## PHEASANT BRANCH GREENWAY ENHANCEMENT

CITY PROJECT NO. 14370

ADDENDUM #2  
REVISED THE FOLLOWING:  
SHEETS D1-D3  
SHEETS EC1-EC4  
SHEETS G13, G15, G112  
SHEETS P1-P19, P21, P24-27  
SHEETS U1-U18, U22  
SHEETS E1-E6  
SHEET PM1  
SHEETS X32A-X34, X45-X48

MARK: 14370  
 Designed By: JFC  
 Date: 11/06/2024 4:00 PM  
 REVISION: AS SHOWN  
 DATE: P9

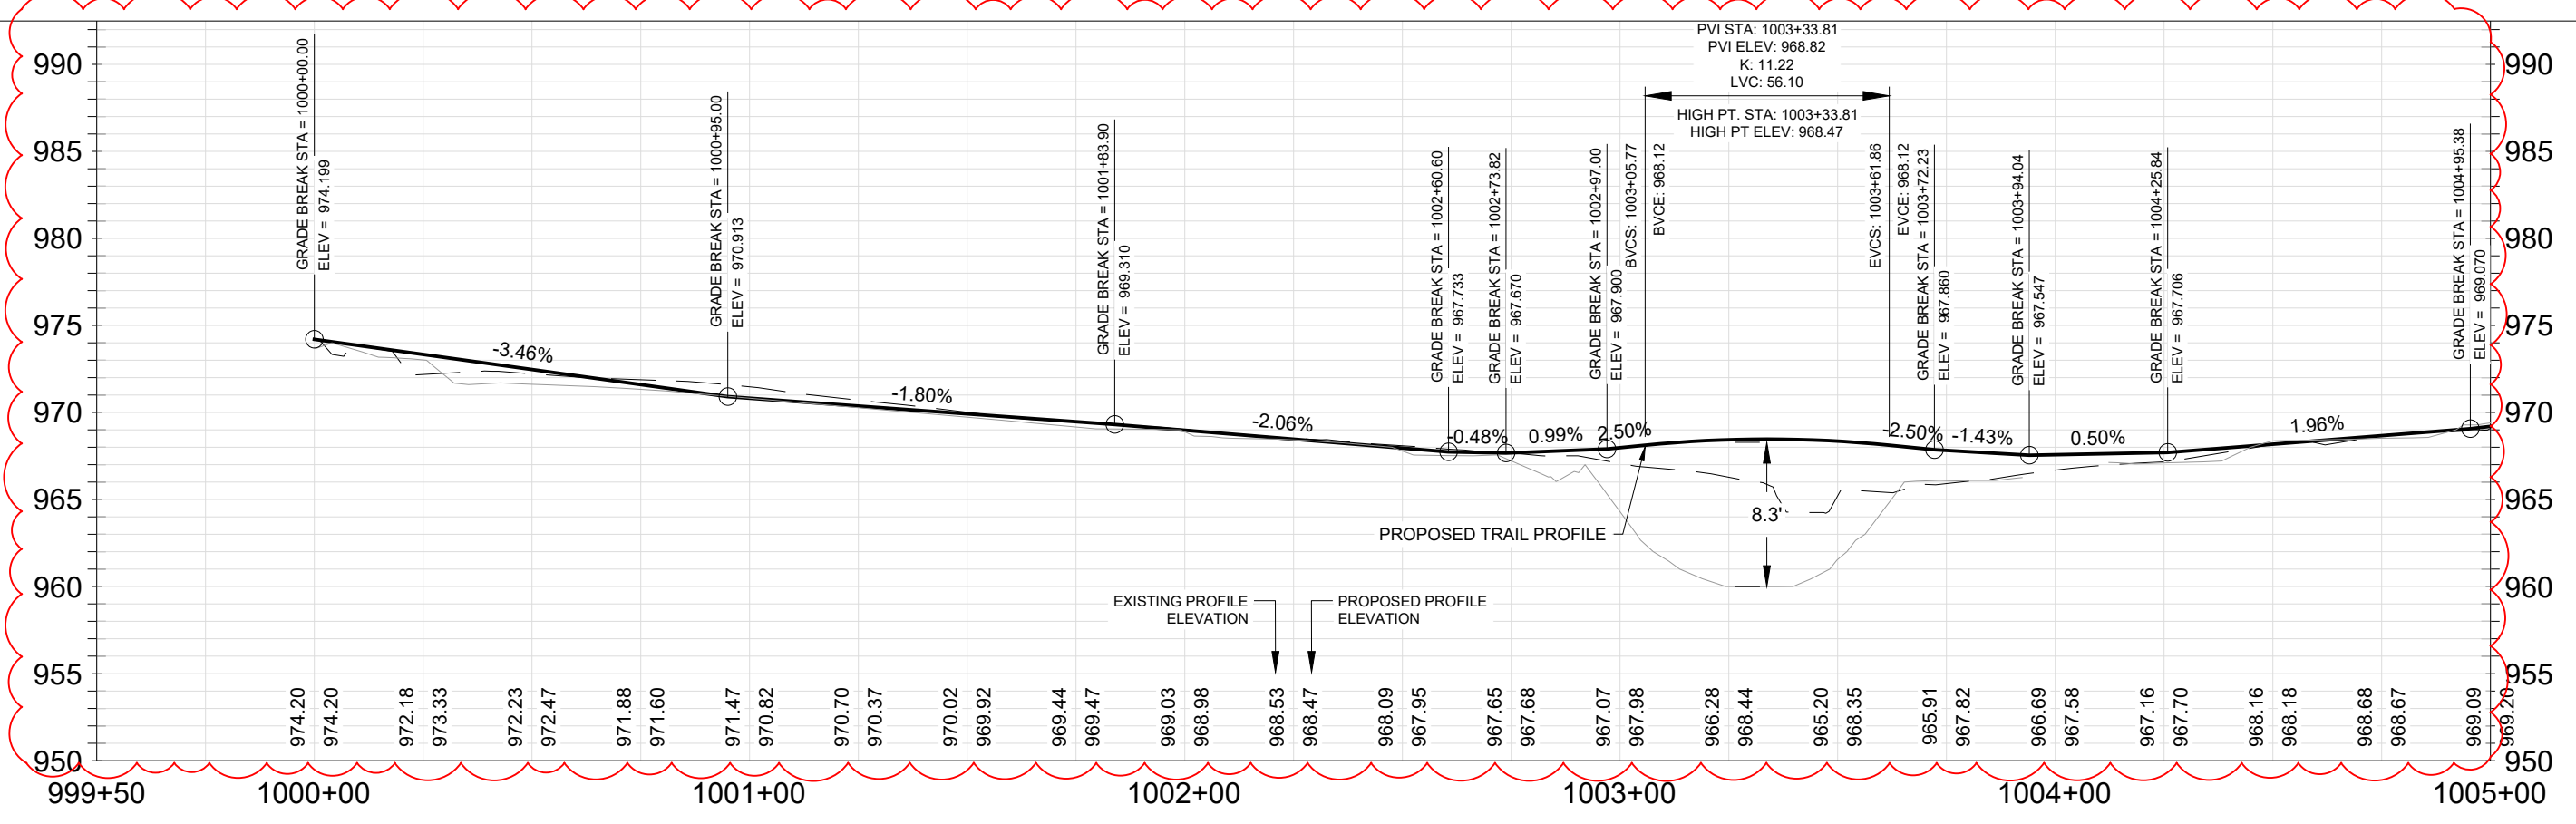
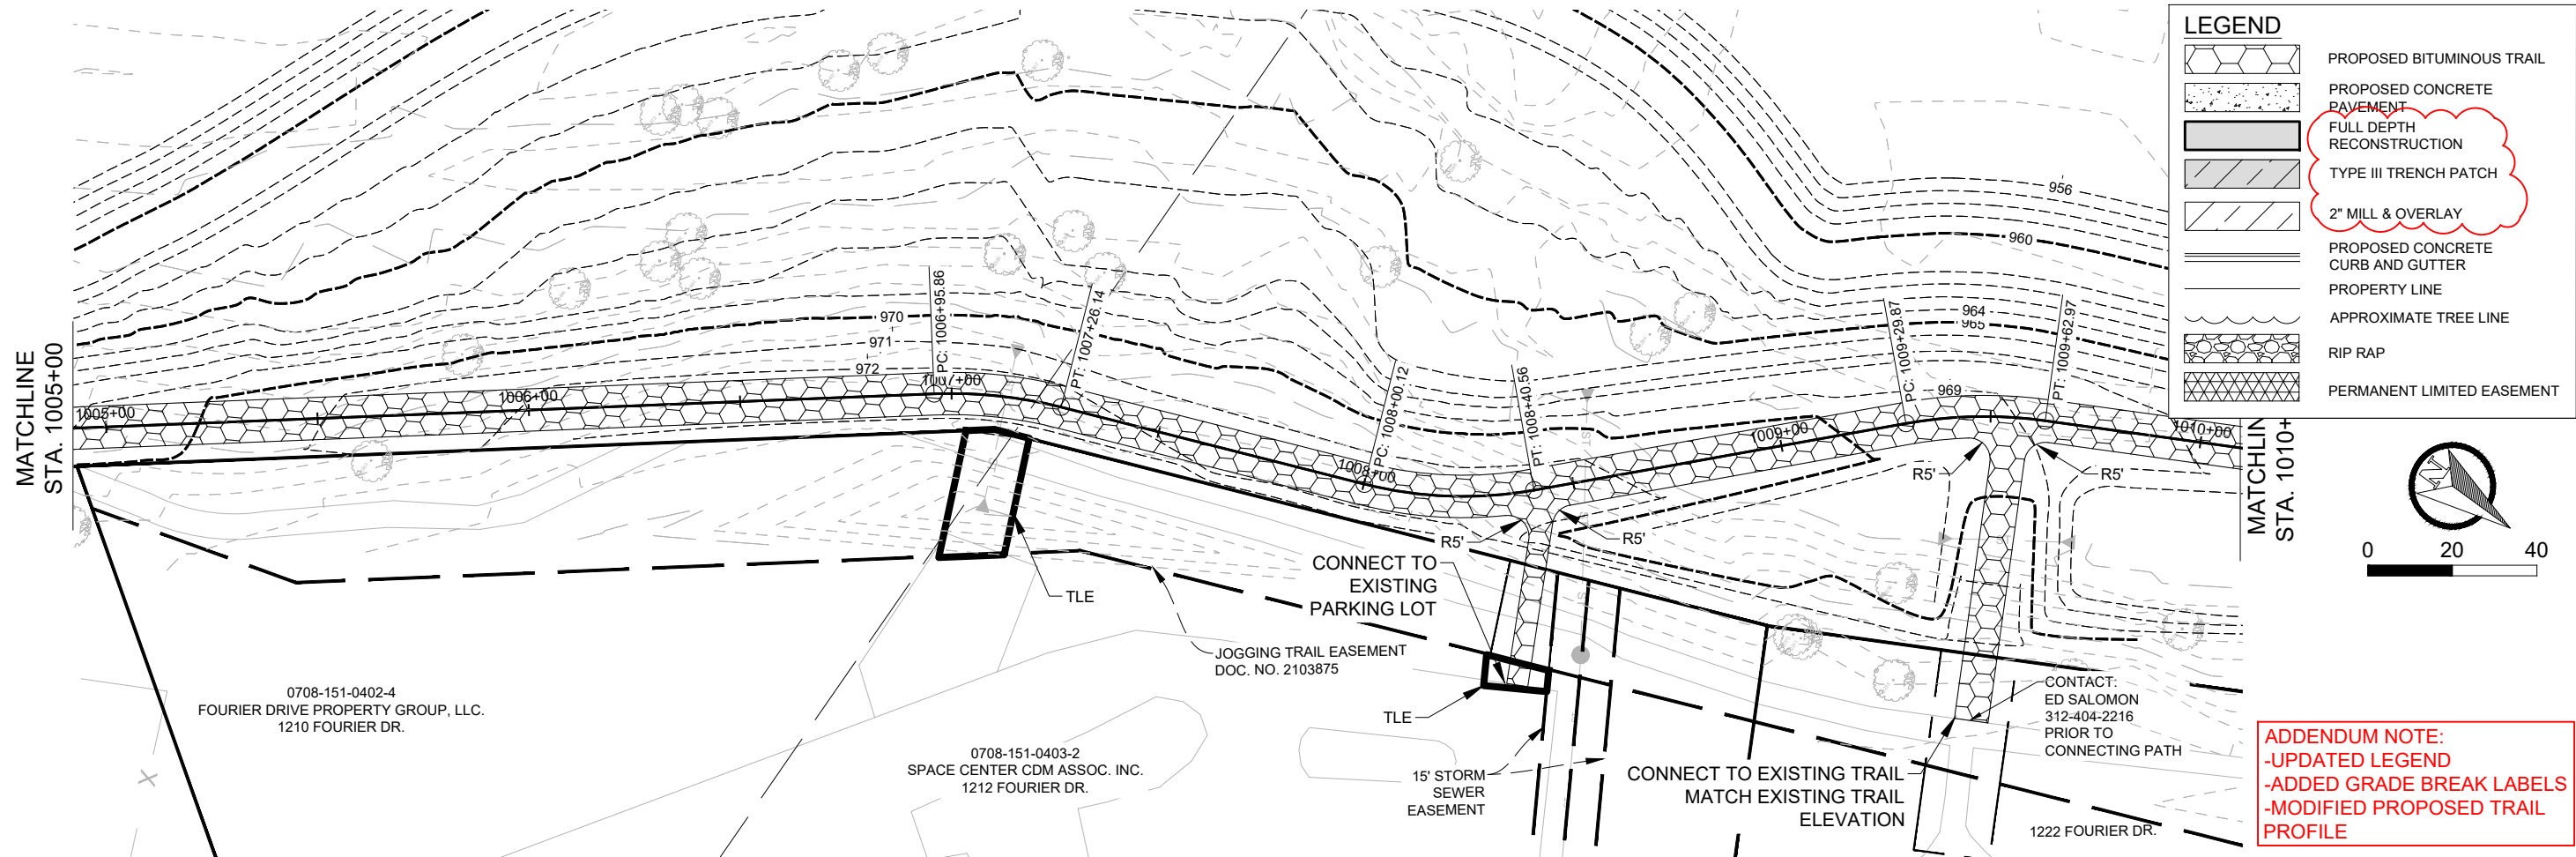
**ADDENDUM NOTE:**  
 -UPDATED LEGEND  
 -ADDED GRADE BREAK LABELS  
 -MODIFIED PROPOSED TRAIL PROFILE  
 -ADDED PRIVATE UTILITY NOTES

MARK	REVISION	DATE	BY
14370	AS SHOWN	11/06/2024 4:01 PM	P11

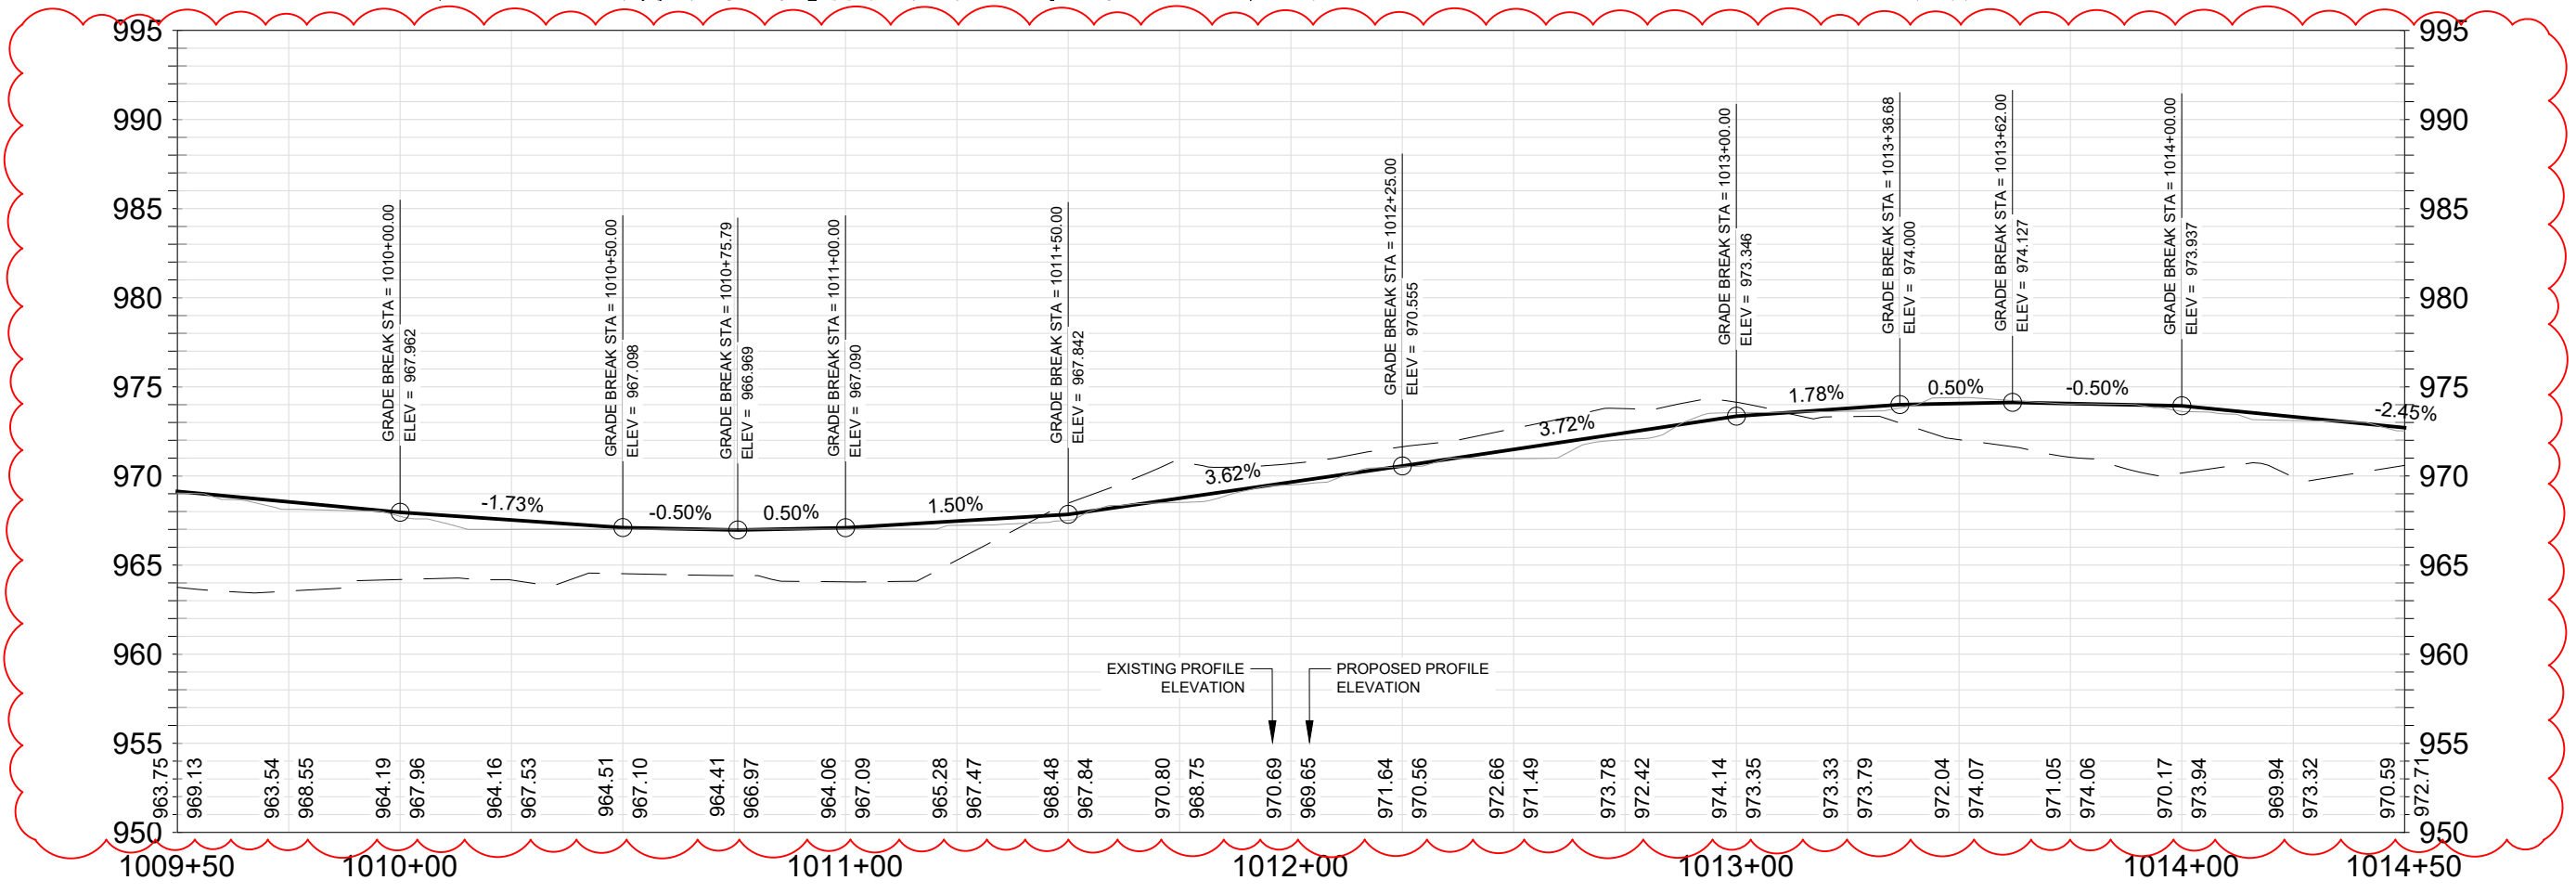
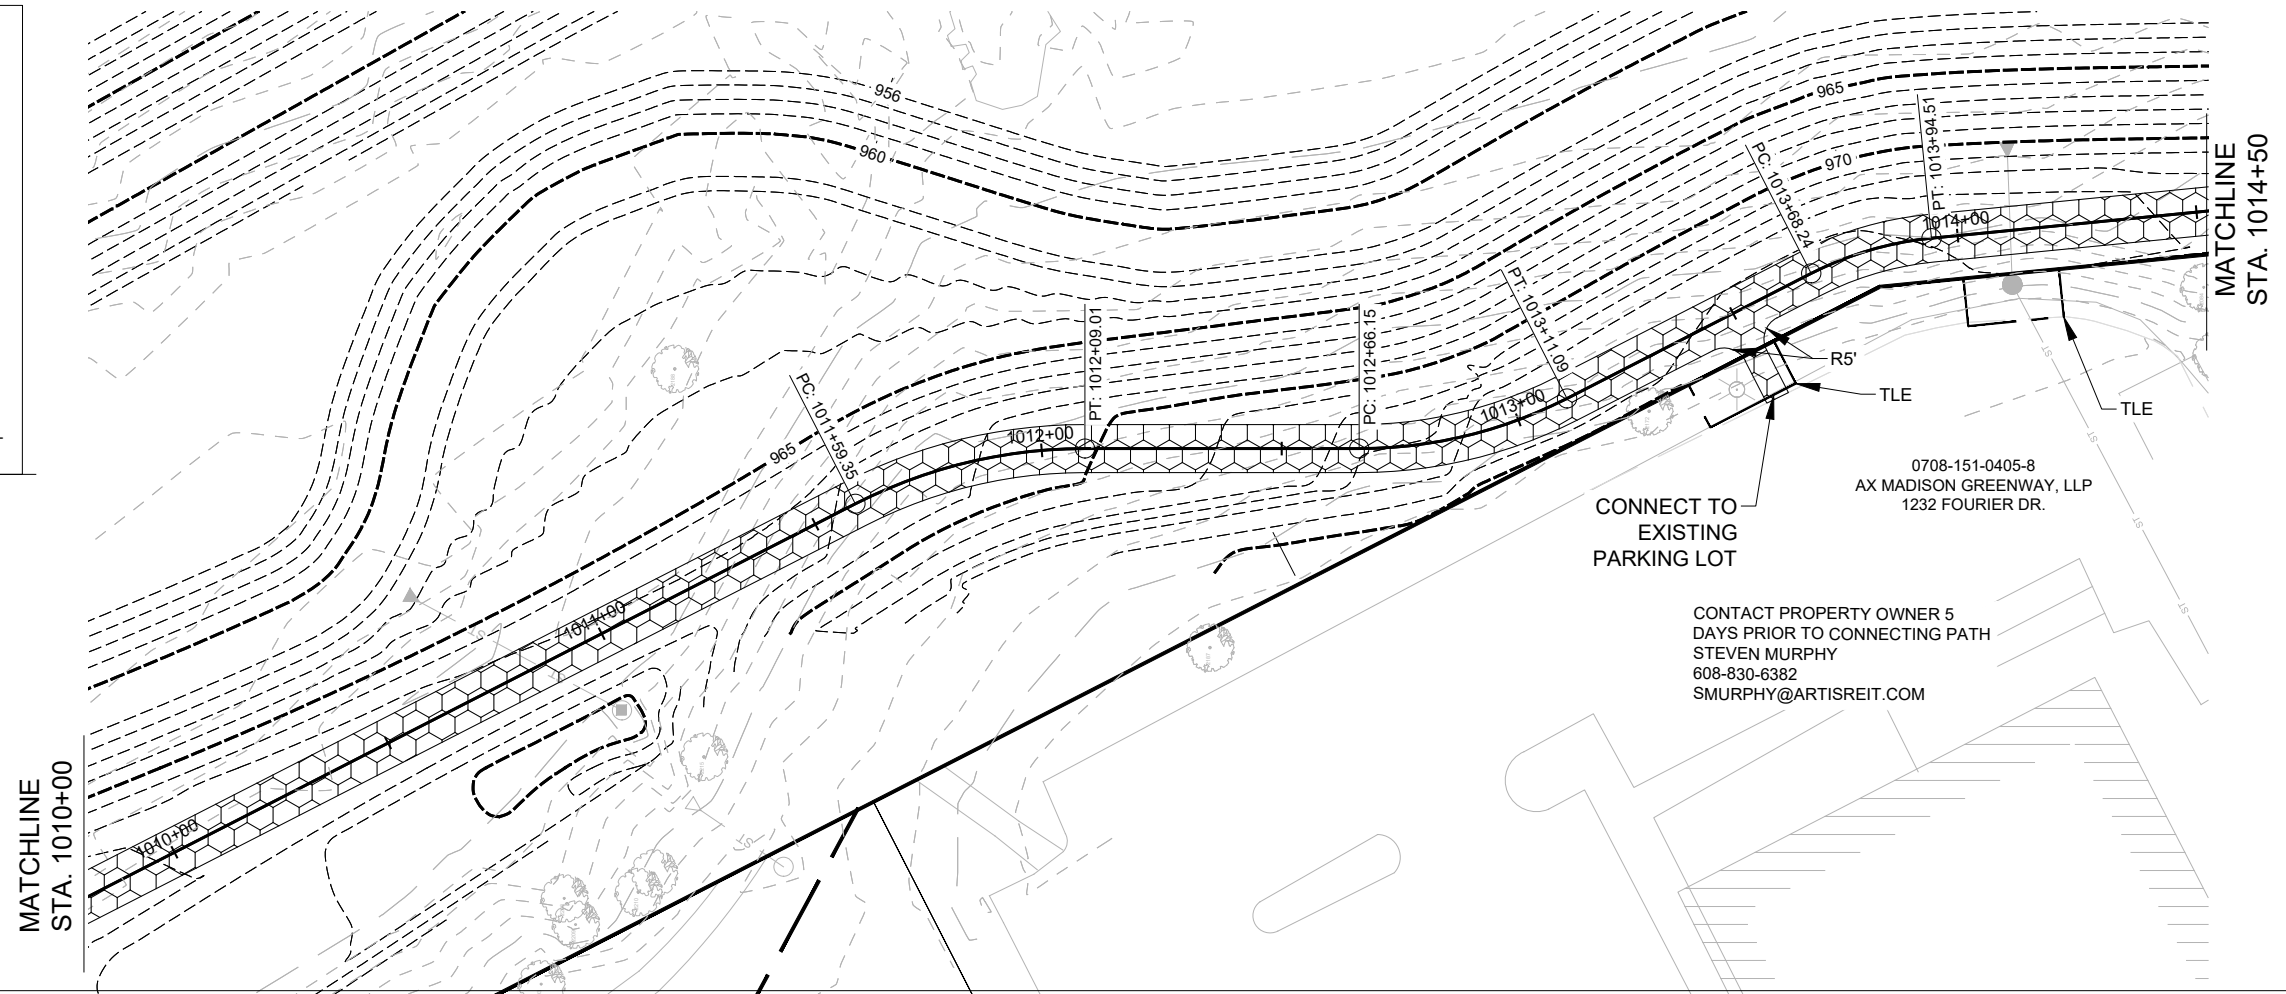
**ADDENDUM NOTE:**  
 -UPDATED LEGEND  
 -ADDED GRADE BREAK LABELS  
 -MODIFIED PROPOSED TRAIL PROFILE

<b>GREENWAY EAST SIDE TRAIL</b> <b>PHEASANT BRANCH GREENWAY ENHANCEMENT</b>	<b>14370</b> <b>P12</b>	<b>14370</b> <b>MADISON, WI</b> <b>9517</b> <b>CONTRACT NO.:</b>
Z:\Clients\A_D\City_of_Madison\Phasant_Branch_Greenway_Enhancement\Engineering\Plan Sheets\0203.0227 Sheet Plan.dwg

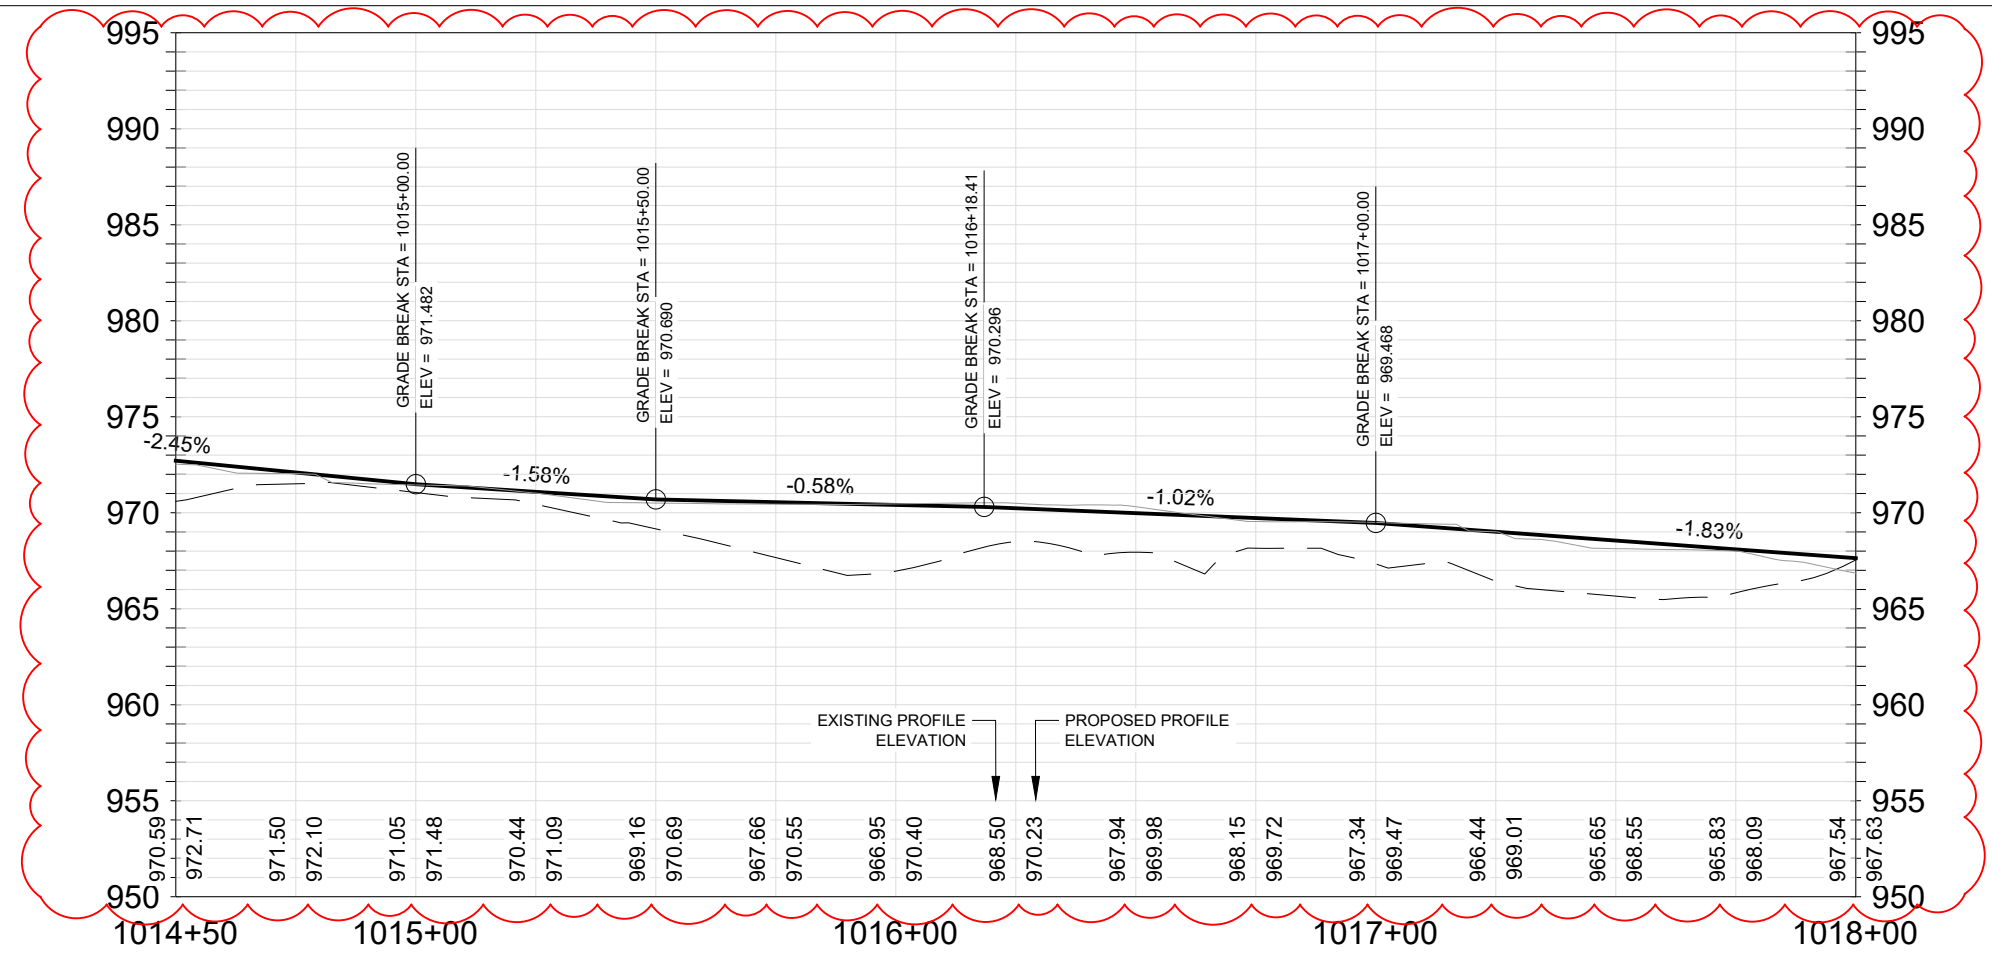
**ADDENDUM NOTE:**  
 -UPDATED LEGEND  
 -ADDED GRADE BREAK LABELS  
 -MODIFIED PROPOSED TRAIL PROFILE
